TRC AGENDA

**CITY OF DELAND
THURSDAY JULY 20, 2023 AT 1:30 P.M.
CITY OF DELAND TRC MEETING ROOM
DELAND, FLORIDA**

City of DeLand
SP23-112
CHIPOTLE

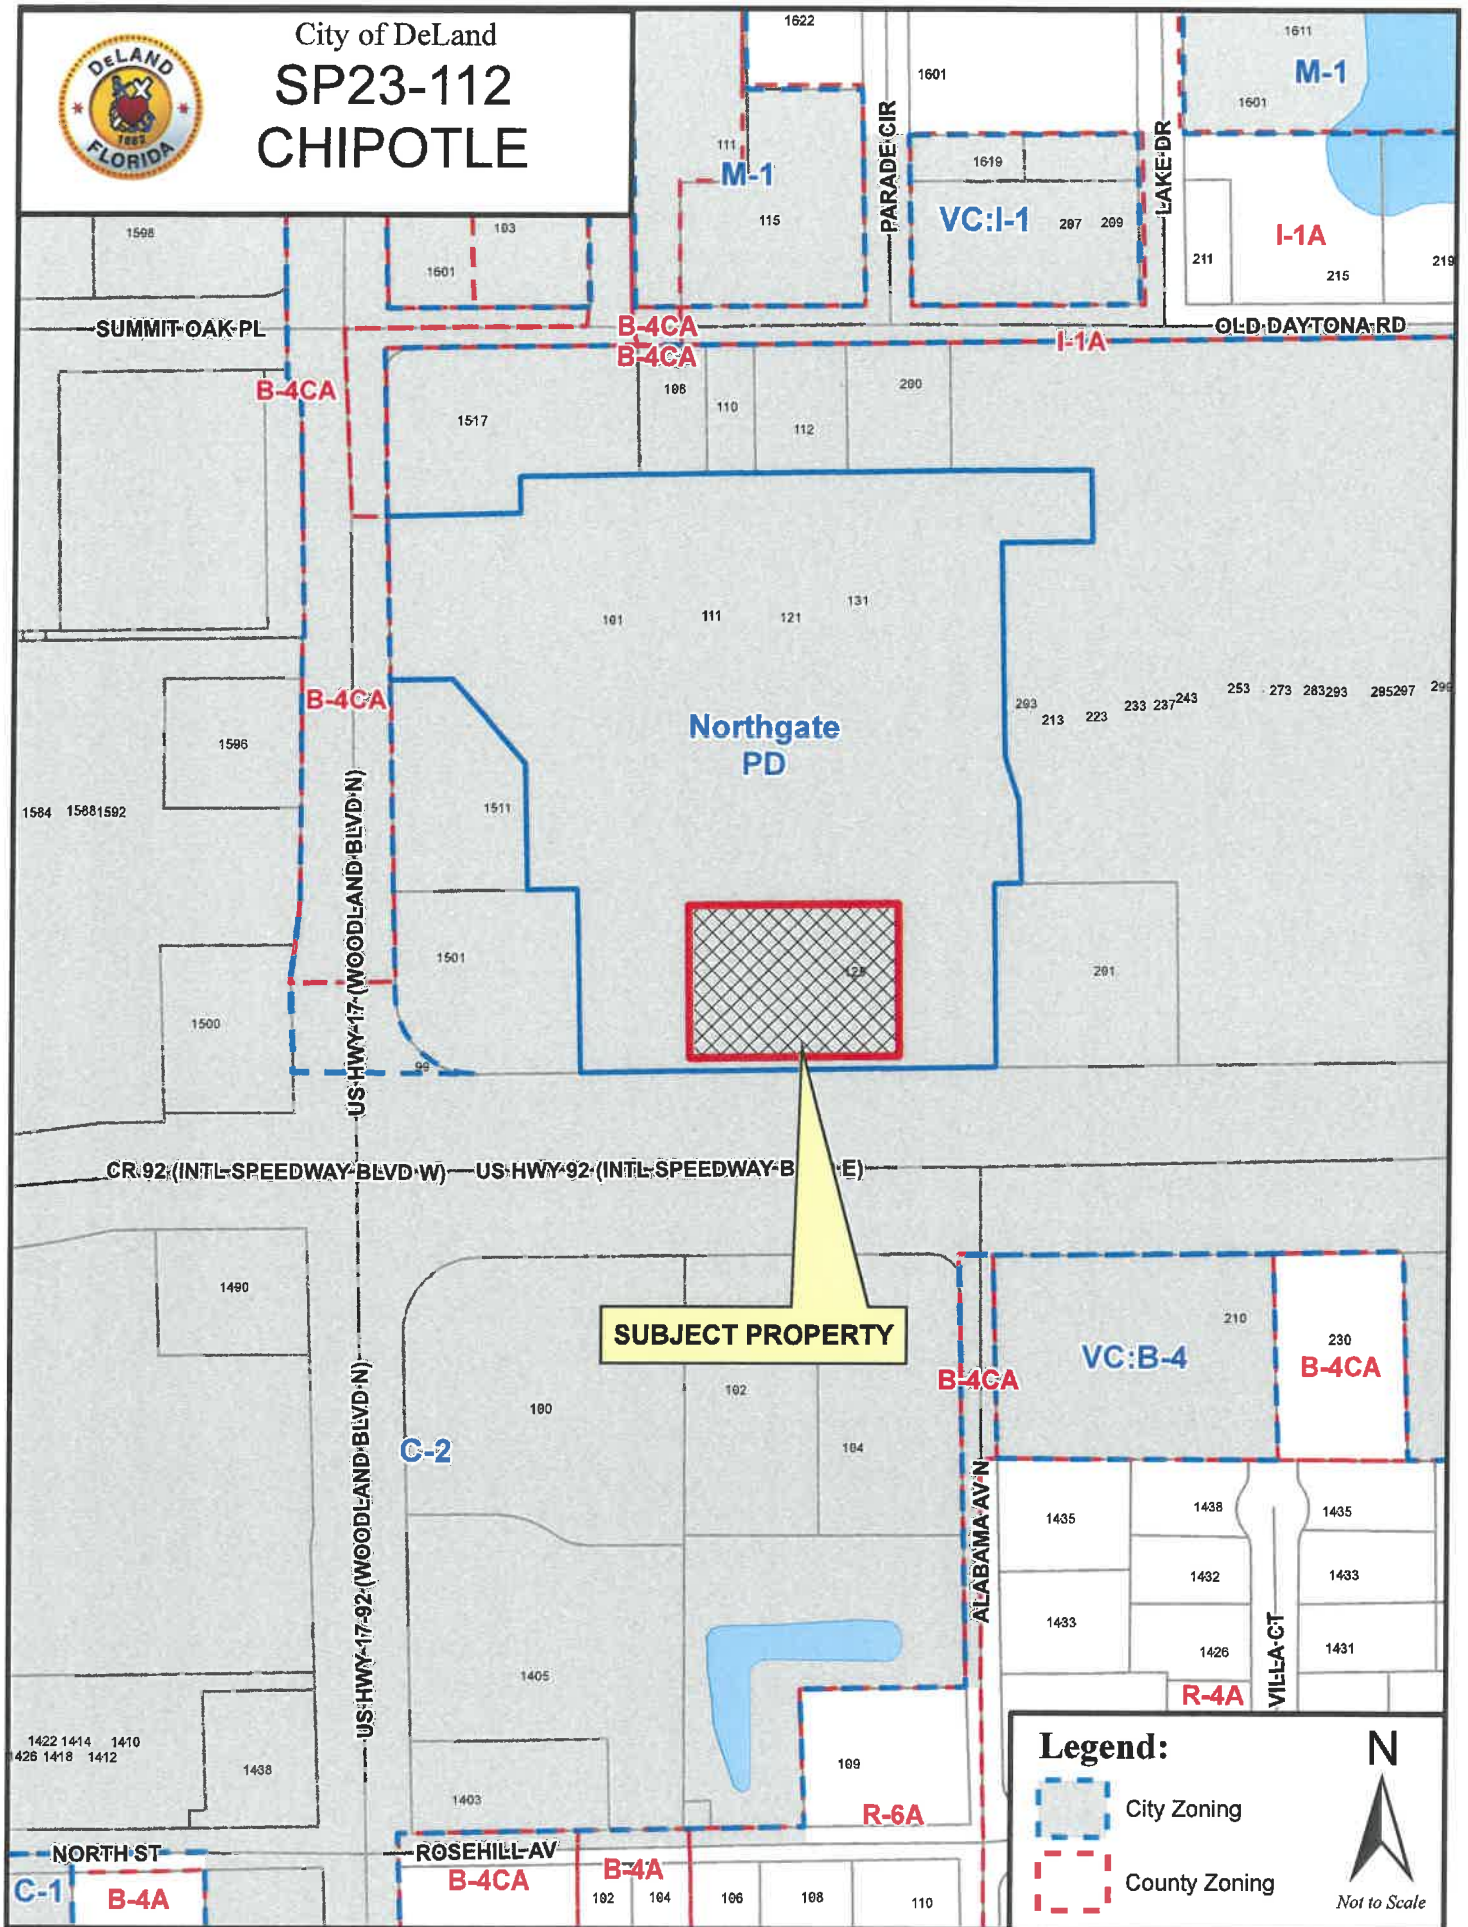
Discipline	Status	Details	Attached To	Created By	Last Updated By	Modifications Required
General Comments						
Engineering	Draft	1. Please check to make sure FDOT Drainage Permit is not required. 2. Will a construction fence be installed within project area boundary? Existing 18" RCP removals on north and east extends beyond project area boundary.		Ray Bahrami	Ray Bahrami	Yes
Cleanout and grease trap invert elevation						
Engineering	Draft	1. Is there a new cleanout proposed for sanitary sewer connection to the building? 2. How is new grease trap connected to existing sanitary sewer main? Please provide invert in and invert out elevation.	C8	Ray Bahrami	Ray Bahrami	Yes
Drainage Arrow and Geotechnical Report						
Engineering	Draft	1. Please show on the plan which existing storm inlets stormwater runoff from project site discharges to by using drainage arrows. 2. Per Note on this sheet, "Contractor to refer to Geotechnical Report for soil requirements and recommendations". Please provide a copy.	C7	Ray Bahrami	Ray Bahrami	Yes

Dumpster						
Engineering	Draft	1. Why is asphalt proposed rather than a 6" concrete in front of the new dumpster? Proposed concrete hatch needs to be shown where proposed concrete pad is located.	C6	Ray Bahrami	Ray Bahrami	Yes
Distance and exit lane width						
Engineering	Draft	1. What is the distance from the east side of the proposed building to back of the curb? 2. Why is a 12' wide lane reduced to 10' by the exit area?	C6	Ray Bahrami	Ray Bahrami	Yes
Roof Drain						
Engineering	Draft	There are two roof drain connections shown on the plan. Where do they discharge to?	C6	Ray Bahrami	Ray Bahrami	Yes
Tree Barricade						
Forestry	Draft		LA1	Kit Dennis	Kit Dennis	Yes

Protected Tree Replacement						
Forestry	Draft	Based on you Plant Schedule, you are planting 4" Cal Magnolias which would equate to 3" DBH trees. Change the DBH in the Protected Tree Replacement chart to 3" DBH and 9" Total DBH Provided.	LA1	Kit Dennis	Kit Dennis	Yes
Tree Specifications						
Forestry	Draft	Please add the spread measurements for the trees. Crape Myrtle - 3.5' SP (8' should be the min height) Magnolia - 6' SP Live oak - 5' SP (The min height for the Live oaks should be changed to 9' as well) All trees should meet Grade 1 specifications in the Florida Grades and Standards.	LA1	Kit Dennis	Kit Dennis	Yes
Site Acreage						
Forestry	Draft	The site acreage (.803 AC) is different from the site acreage on sheet C1 (.839 AC). Please correct whichever sheet that is not accurate. If sheet C1 is the accurate site size, the minimum DBH required for the site would need to be changed to 88 inches.	LA1	Kit Dennis	Kit Dennis	Yes

Trash Enclosure						
Planning	Draft	Please include elevations for the trash enclosure and confirm it will match in appearance to the primary building.	A301	Samuel Nelson	Samuel Nelson	Yes

City of DeLand
FSB23-117
Lakewood Park
Phase 3

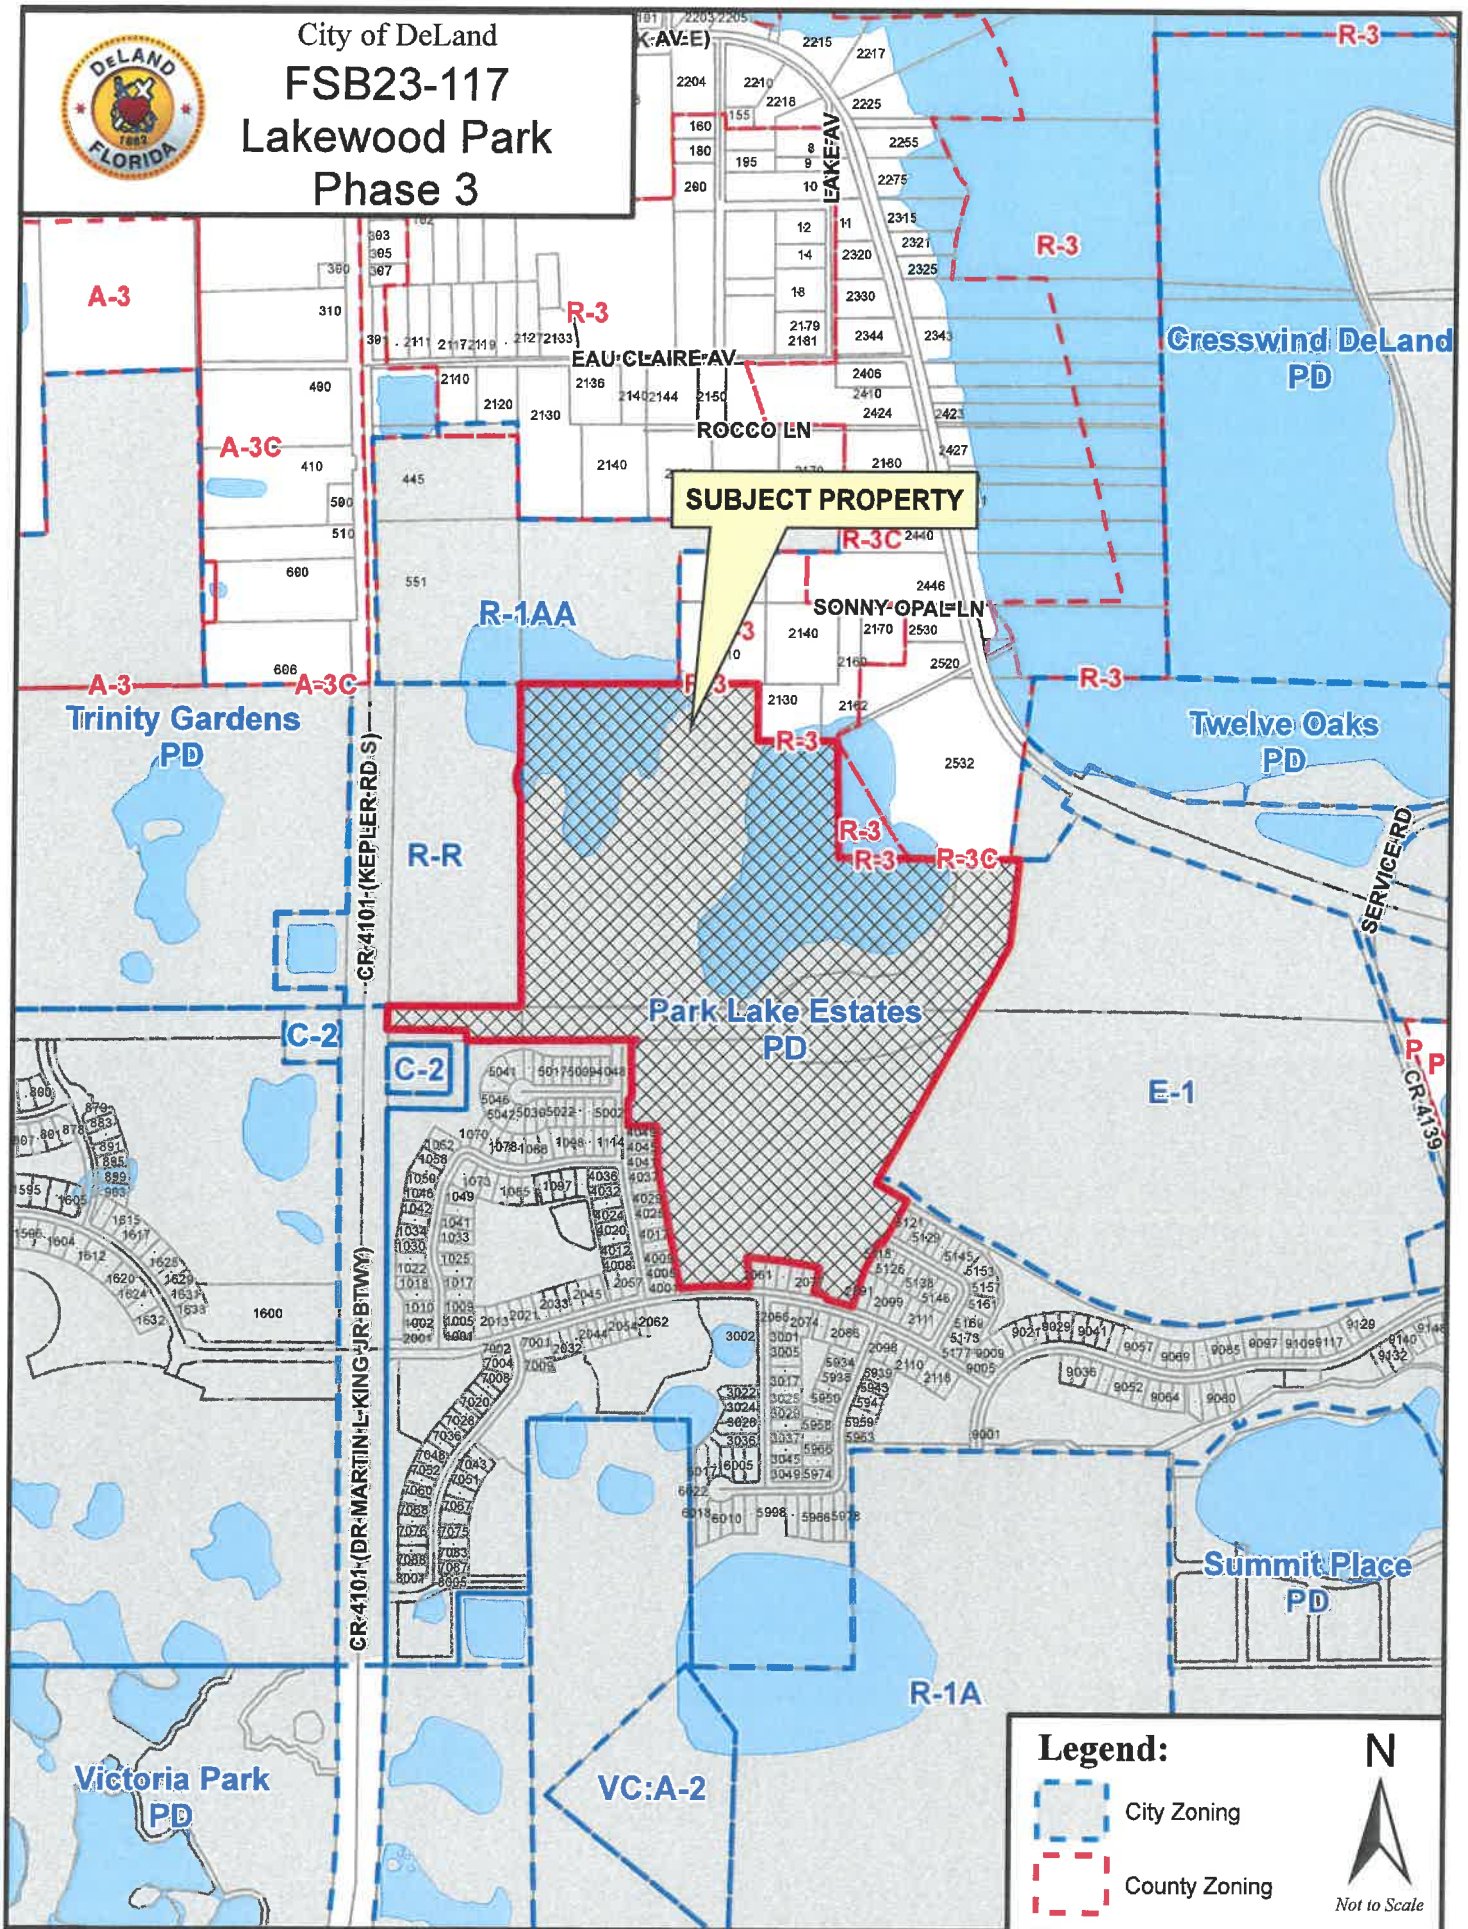
Discipline	Status	Details	Attached To	Created By	Last Updated By	Modifications Required
Notes 5 and 8						
Forestry	Draft	Note 5 includes a TPA-15, which is not included in Note 8, which has a TPA-14A listed, which does not appear to be included in the next few pages. Please update the notes to match actual TPA numbers.	SHEET 1 OF 7	Mariellen Calabro	Mariellen Calabro	Yes
Forestry	Draft	Note 2 Change US to USE in line 2.	SHEET 1 OF 7	Mariellen Calabro	Mariellen Calabro	Yes
Adjustments						
Planning	Draft	The PD agreement and legal description will need to be updated to reflect the adjusted property parameters for the removal of TPA-15.	SHEET 1 OF 7	Belinda Collins	Belinda Collins	Yes
TPA						
Planning	Draft	Due to the reduction of the overall project size (TPA reduced by 3.41 acres) the project does not meet the minimum TPA requirement of 15%. The PD agreement needs to be revised to address the removal of TPA-15 and allow for a reduced minimum TPA%.	SHEET 2 OF 7	Belinda Collins	Belinda Collins	Yes

Clean up items						
Planning	Draft	Cleanup items: - Item 2 – "...for the perpetual use of the public utilities." - Item 8 – Clarify if there is a Tract TPA-14A - Item 18 - Fix spelling/grammar of several words in the text. - Item 19 - Fix spelling/grammar of several words in the text. - Item 21 - Fix spelling/grammar of several words in the text. - Dedication block – paragraph 6 correct wetland buffers notation from 1B-14 to WB-14.	SHEET 1 OF 7	Belinda Collins	Belinda Collins	Yes
